## ADMINISTRATIVE SITE DEVELOPMENT PLAN REPORT & DECISION

**REPORT DATE:** September 23, 2014

**Project Name:** Hotel at Soutport

**File Number:** LUA14-000645, SA-A, SM, MOD, MOD

EXHIBIT 4

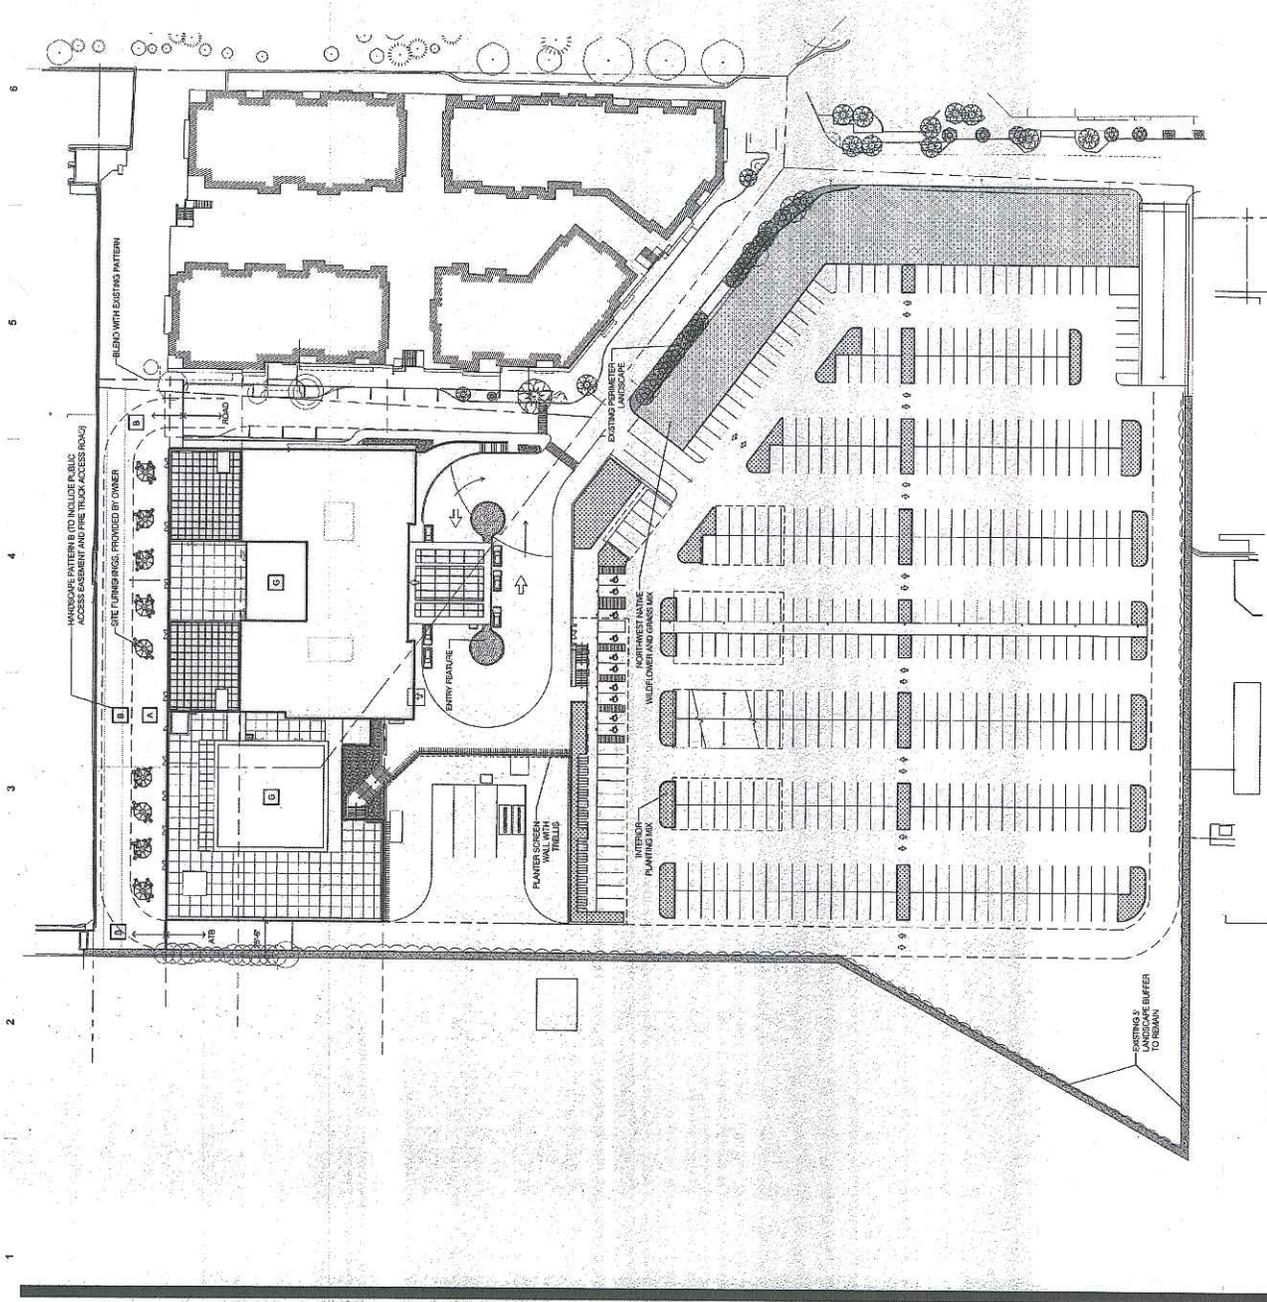
<p><i>perimeter landscaped buffers. Following complete build out the Southport Development is anticipated to have impervious surface cover of approximately 85%.</i></p>
✓	<p><b>Landscaping:</b> Use of landscaping to soften the appearance of parking areas, to provide shade and privacy where needed, to define and enhance open spaces, and generally to enhance the appearance of the project. Landscaping also includes the design and protection of planting areas so that they are less susceptible to damage from vehicles or pedestrian movements.</p> <p><u>Staff Comment:</u> See Landscaping discussion above.</p>
<b>g. ACCESS:</b>	
✓	<p><b>Location and Consolidation:</b> Providing access points on side streets or frontage streets rather than directly onto arterial streets and consolidation of ingress and egress points on the site and, when feasible, with adjacent properties.</p> <p><u>Staff Comment:</u> Access is provided via an internal private street connected to Lake Washington Blvd NE. Access to Lake Washington Blvd NE is coordinated with the Puget Sound Energy storage site and Gene Coulon Park but cannot be consolidated due to existing conditions.</p> <p><i>Adequate and safe vehicular access improvements to and from the project site and neighboring properties have been completed or are planned for construction within the next year.</i></p> <p><i>Creation of a dedicated left-turn lane on Lake Washington Blvd NE has already been constructed. The applicant is proposing the addition of two lanes into Gene Coulon Park from Lake Washington Blvd NE and the signalization of the intersection. Additionally, the applicant is also proposing the installation of the railroad crossing arms at the entrance of the development. The planned improvements include channelization for turning movements to and from both Gene Coulon Park and Southport. The improvements would provide for better turning movements to and from Lake Washington Blvd NE.</i></p> <p><i>The major access point to the parking lot, which is at the southeast corner of the lot, is located as far away from the waterfront and as close to access to Lake Washington Boulevard NE as possible in order to minimize parking conflicts between hotel guests, office tenants, and residents. The internal street provides integrated access to street and parking facilities for both the hotel and the office buildings as well as a drop-off point for hotel guests, visitors, and tour groups that is separate from other uses at Southport.</i></p> <p><i>The proposed development is expected to maintain the safety and efficiency of pedestrian and vehicle circulation on the site if all conditions of approval are complied with.</i></p>

6. The applicant shall submit a revised and detailed landscape plan complying with the following: a mixture of trees, shrubs, and groundcover. The revised detailed landscape plan, shall be submitted to, and approved by, the Current Planning Project Manager prior to construction permit issuance.

EXHIBIT 5

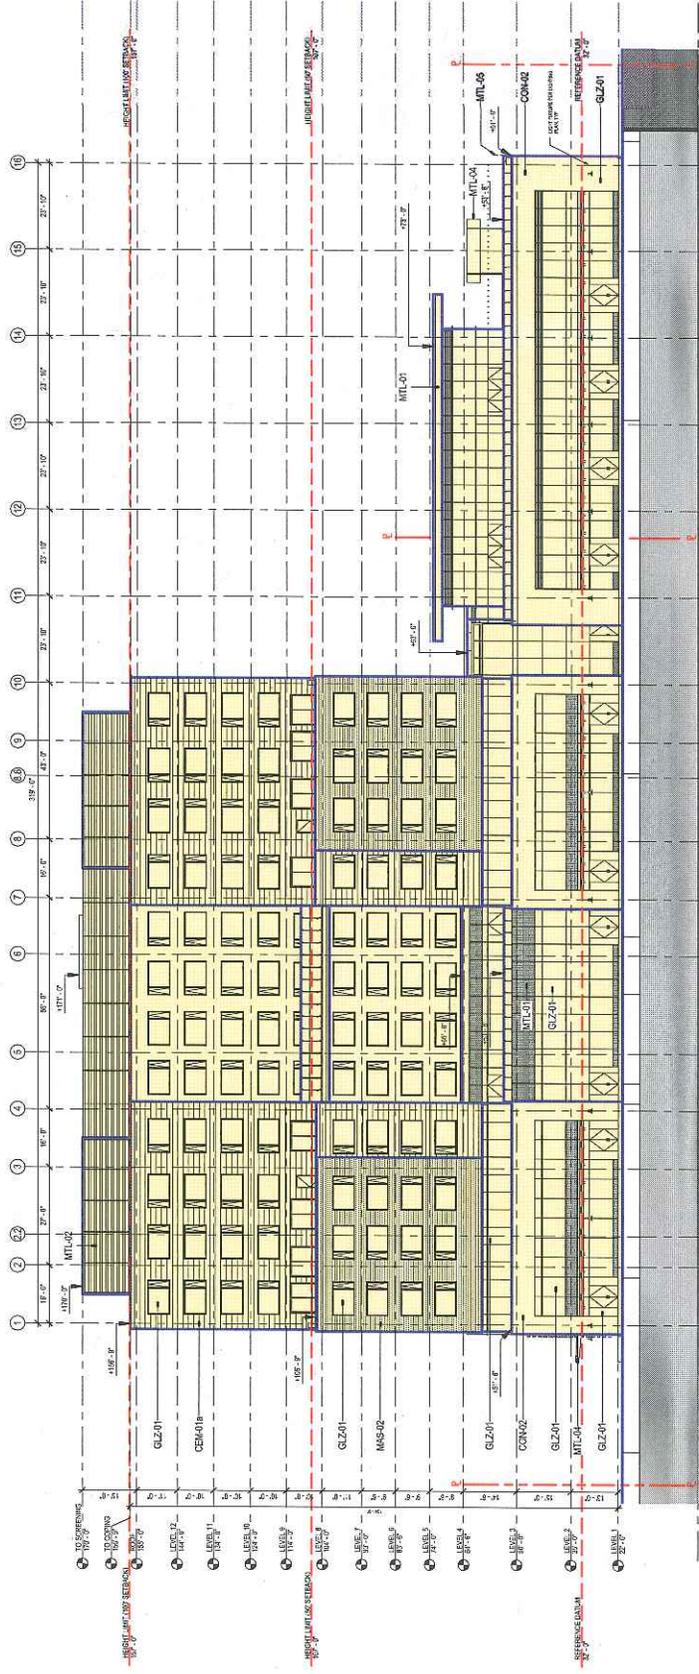
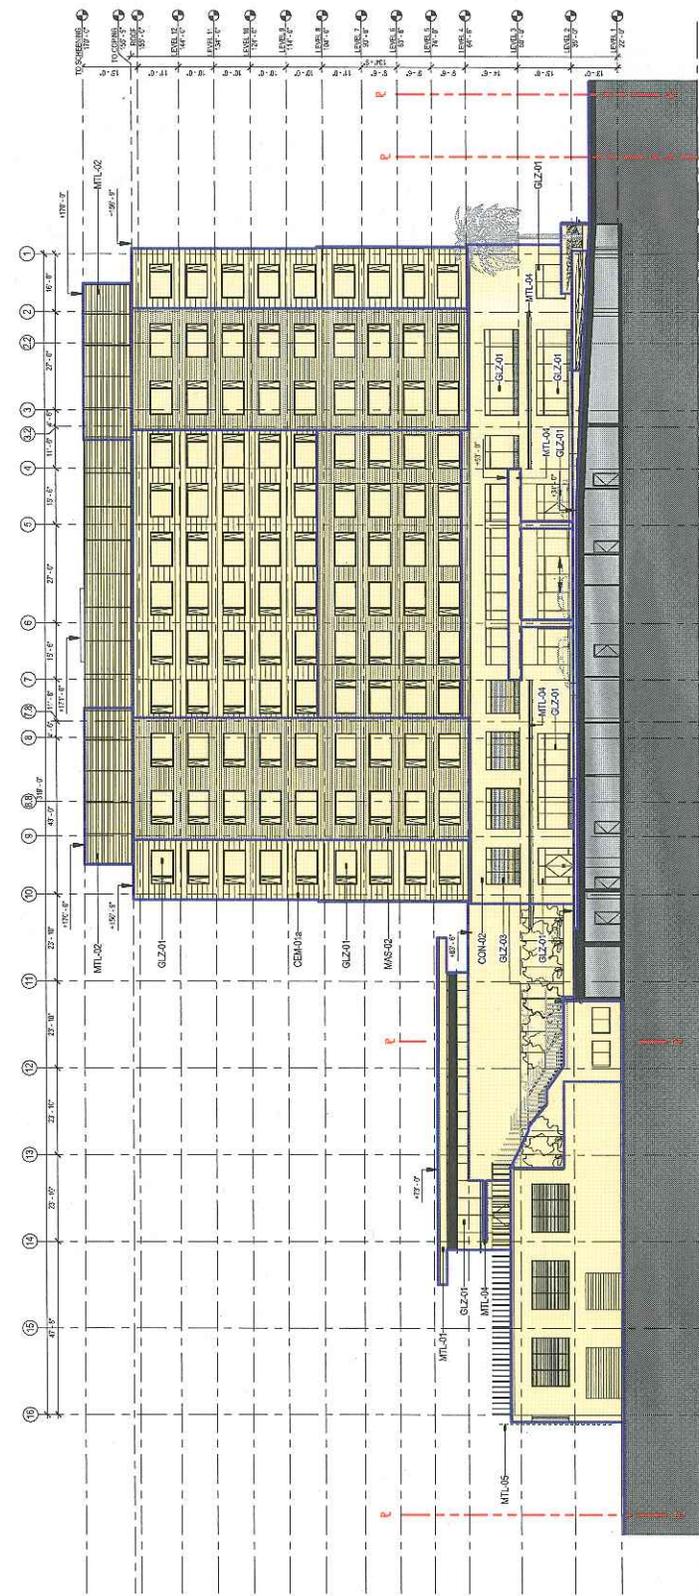
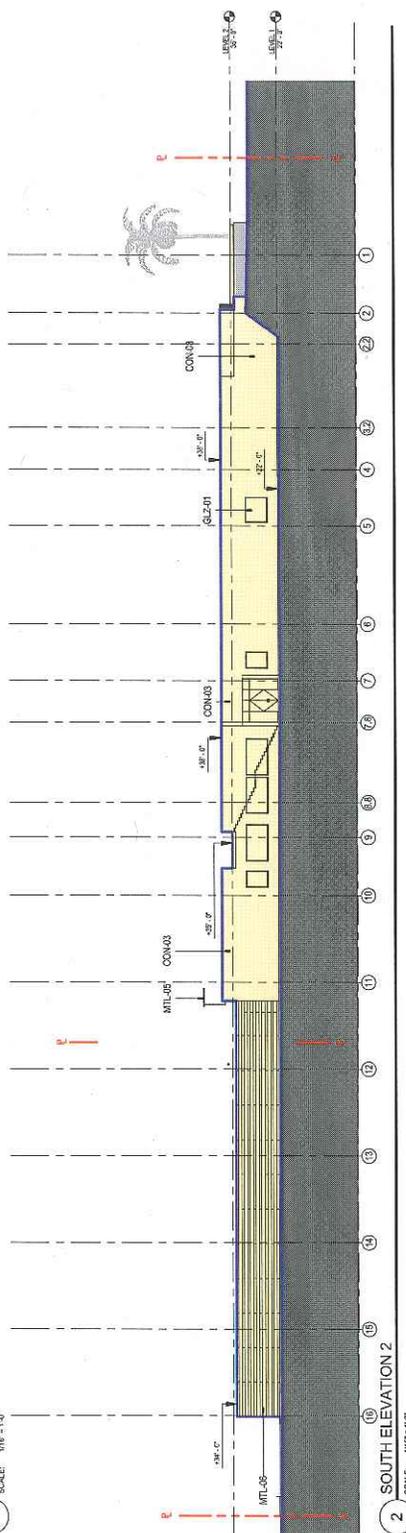
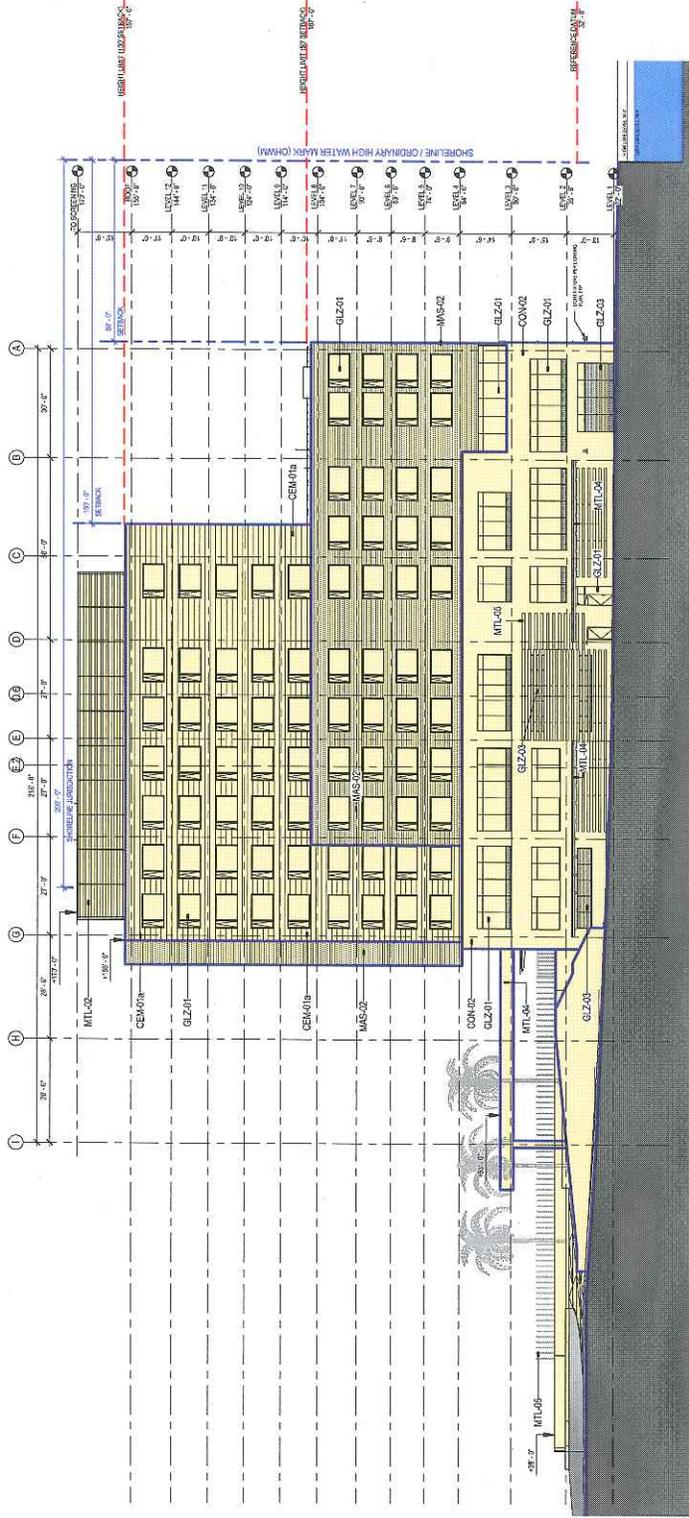
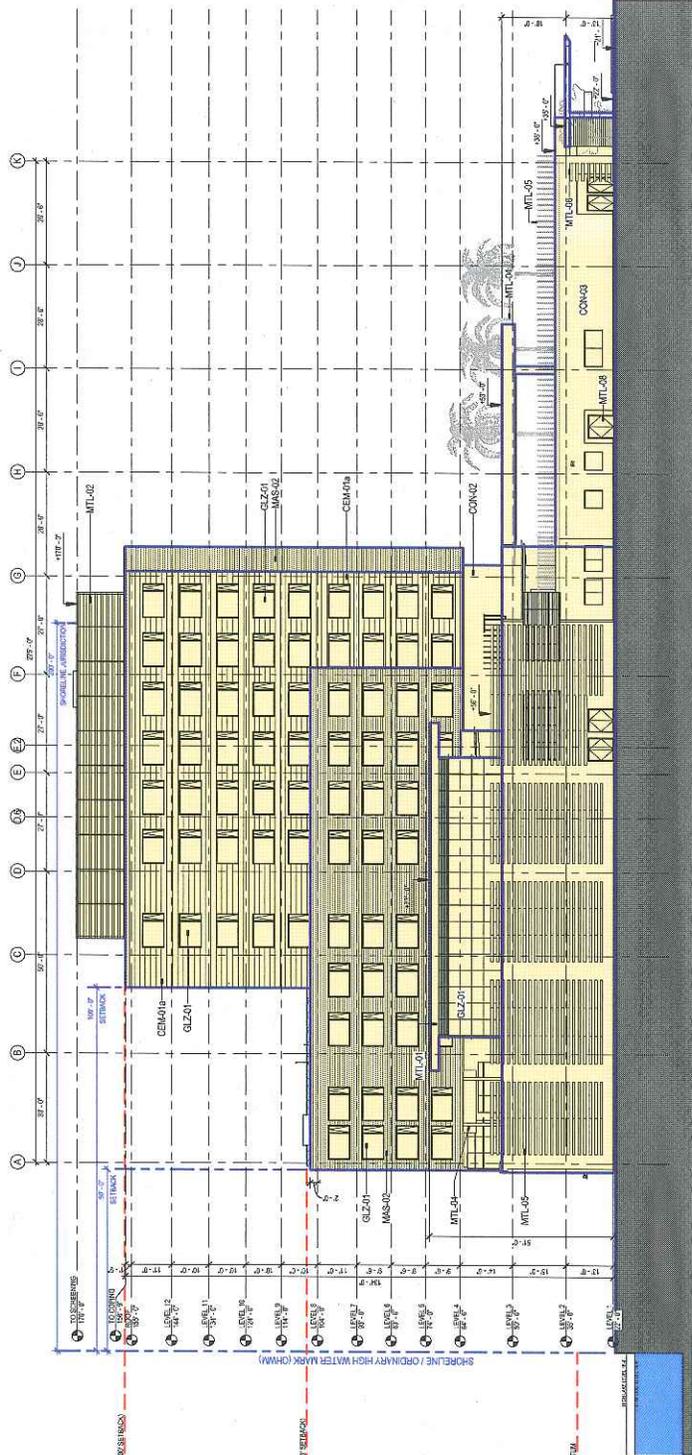
<p>✓</p>	<p><b>Modulation and Articulation:</b> Incorporate building modulation to reduce the overall bulk and mass of buildings.</p> <p><u>Staff Comment:</u> The proposed hotel building is adjacent to the Bristol Apartments, the Boeing Facility, and future office buildings. In order to create articulation and modulation and reduce the overall bulk and mass of the hotel building the applicant has proposed changes to the exterior materials on the building, vertical plane changes, changes in the color, superior window design, and contrast between solid wall panels and transparent glass areas.</p> <p>The applicant is proposing a variety of concrete wall panel exterior materials, including cast in place concrete and architectural concrete wall panels which vary in color and texture on Floors 1, 2 and 3. Floors 4 through 7 would have a combination of brick and cement panels</p>

<p><i>similar in character to the neighboring Bristol Apartments. Proposed Floors 8 through 12 would also have cement panels similar in color to those used on the Bristol Apartments and proposed for use for the future office buildings (Exhibit 5).</i></p> <p><i>The applicant has designed exterior wall panels to create a plinth/platform for each change of material above. The concrete base would extend 6-8 inches from the face of the brick wall above and the brick would extend 4-6-inches from the face of the cement wall panels above.</i></p> <p><i>The applicant is proposing storefront windows on Floors 1-3 which serves to maximize views to the water and surroundings. All windows on the upper stories are punched window style. The upper level window frames are flush with the cement wall panel exterior, recessed 4-inches from the exterior face of the proposed brick, and 6-8 inches within the concrete podium.</i></p> <p><i>The applicant has yet to select final colors for the proposed hotel but indicates the colors used would be similar to those used on the Bristol Apartments. Staff recommends, as a condition approval, the applicant provide a material/colors board to the Current Planning Project Manager prior to the building permit approval. The materials board shall demonstrate compatibility with the Bristol Apartments and future office buildings.</i></p> <p><i>The articulation and modulation of the hotel building facades is in keeping with the surrounding buildings in the neighborhood.</i></p>

5. The applicant shall provide a material/colors board to the Current Planning Project Manager prior to the primary building permit approval. The materials board shall demonstrate compatibility with the Bristol Apartments and future office buildings.

UPPER STORY SETBACK MASS DIAGRAMS  
 A950

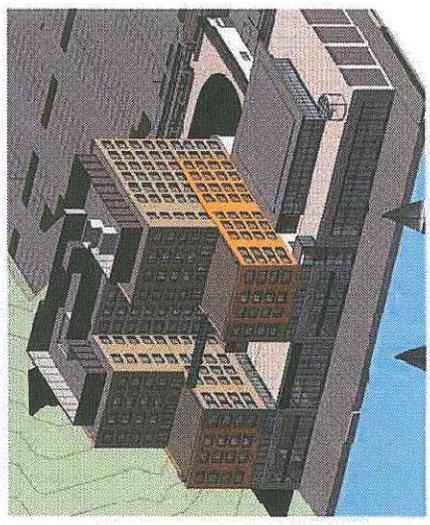
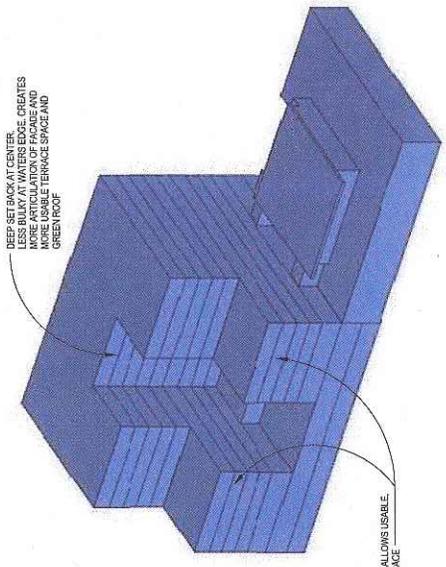
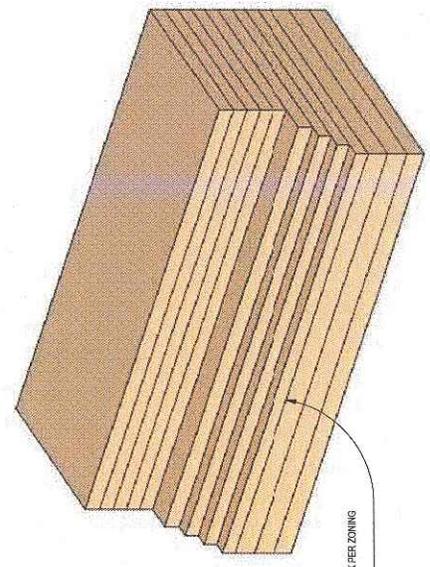
✓	<p><b>Upper Story Setbacks:</b> Per RMC4-2-120 Buildings or portions of buildings which exceed 50-feet in height which are located within 100 feet of the shoreline shall include upper story setbacks for the façade facing the shoreline and for facades facing publicly accessible plazas as follows: The minimum setback for a fifth story and succeeding stories shall be 10 feet. Projects not meeting the upper story setbacks may be approved through a modification process. Application may be made for modification of the upper story setback standards when superior design is demonstrated pursuant to RMC 4-9-250D. For a modification to be granted, the project must also comply with the decisions and design criteria stipulated in RMC 4-9-250D2 and D4.</p> <p><u>Staff Comment:</u> <i>The applicant contends that the proposed hotel offers a superior design solution as an alternative to the upper story setback requirement. Pursuant to RMC 4-9-250D the applicant has requested a modification to the upper story setbacks requirement found in RMC 4-2-120B.</i></p> <p><i>Section 4-9-250 allows a grant of relief from the requirements of the code which permits construction in a manner that otherwise is prohibited, provided the modification meets the following criteria:</i></p> <ul style="list-style-type: none"><li><i>a. Will meet the objectives and safety, function, appearance, environmental protection and maintainability intended by the Code requirements, based upon sound engineering judgment; and</i></li><li><i>b. Will not be injurious to other property(ies) in the vicinity; and</i></li><li><i>c. Conform to the intent and purpose of the Code; and</i></li><li><i>d. Can be shown to be justified and required for the use and situation intended; and</i></li><li><i>e. Will not create adverse impacts to other property(ies) in the vicinity; and</i></li><li><i>f. In comparison to the standard upper story setbacks, the proposed building design will achieve the same or better results in terms of solar access to the public shoreline trails/open space and publicly accessible plazas; the building will allow access to sunlight along the public trail/open space system and plazas abutting</i></li></ul>
